Comments on PA 03853/20 - Proposed reconstruction and extension of existing concrete quay, repair to existing arm, reconstruction of existing 2 slipways and replacement of existing concrete pavement

Figure 1: Aerial view at night of Marfa jetty showing incompatible and insensitive lighting at night of the area

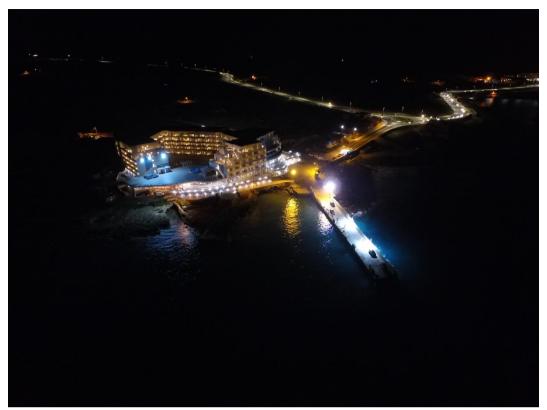
The current lighting schemes in the area do not correspond to best sustainable practices and are a source of significant light pollution. For instance the Marfa jetty located in close proximity, has a number of installed high intensity LED floodlights angled poorly causing light spill; light is unnecessarily on during night hours instead of reducing it to required period of time when vessels load/unload

Light pollution has adverse impact on seabirds, and the largest colony of Yelkouan Shearwaters nesting on cliffs of L-Irdum tal Madonna is most likely to be affected if the jetty will include any additional lighting or will be a source of further boat traffic/habitation of the area.
